Staff Report

REPORT NO.: DSD-2025-330

SUBJECT: Minor Variance Application A2025-079 – 706 Frederick Street
(Future Severed Parcel)
Minor Variance Application A2025-080 – 706 Frederick Street
(Future Retained Parcel)

Figure 4 - 707-709 and 711-713 Frederick Street Aerial

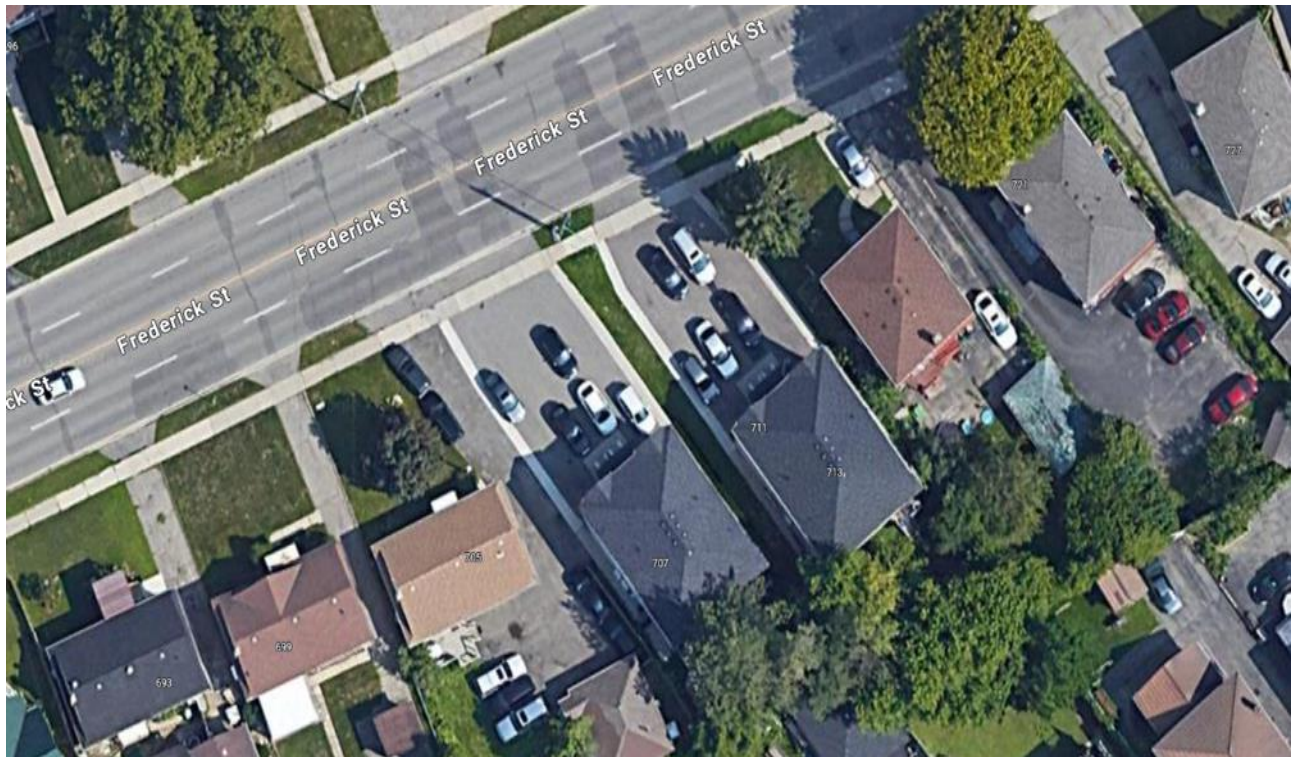
To further highlight the intent of the zoning requirement for a 10.5 metre lot width is the existing parking arrangement, directly across the road from the subject property at 707-709 and 711-713 Frederick Street, two semi-detached buildings, each duplexed (only two (2) dwelling units in each half of a Semi-Detached Dwelling, four dwelling units 4 per lot across four (4) lots for a total of eight (8) dwelling units; rather than 8 dwelling units on two (2) lots per the subject proposal). As demonstrated in the aerial in Figure 4, the sites provide side-by-side parking (which was legally permitted at the time of their construction; this design is no longer permitted in Zoning By-law 2019-051) allowing for each of the duplexed units their own "lane" in the side-by-side arrangement. A single, three-long tandem parking arrangement is not an appropriate use for a fourplex; for lots outside the 800 metre radius of an LRT Station and outside the Central Neighbourhood Area.

To further highlight the concerns with the proposed parking arrangement, directly across the road from the subject property are 707-709 and 711-713 Frederick Street, two semi-detached buildings, each duplexed (two units per lot across four lots for a total of eight units). As demonstrated in Figure 4, the sites provide side-by-side parking (which was legally permitted at the time of their construction; this design is no longer permitted in

Zoning By-law 2019-051) allowing for each of the duplexed units their own “lane” in the side-by-side arrangement. A single, three-long tandem parking arrangement is not an appropriate use for a fourplex; nevertheless two beside each other.
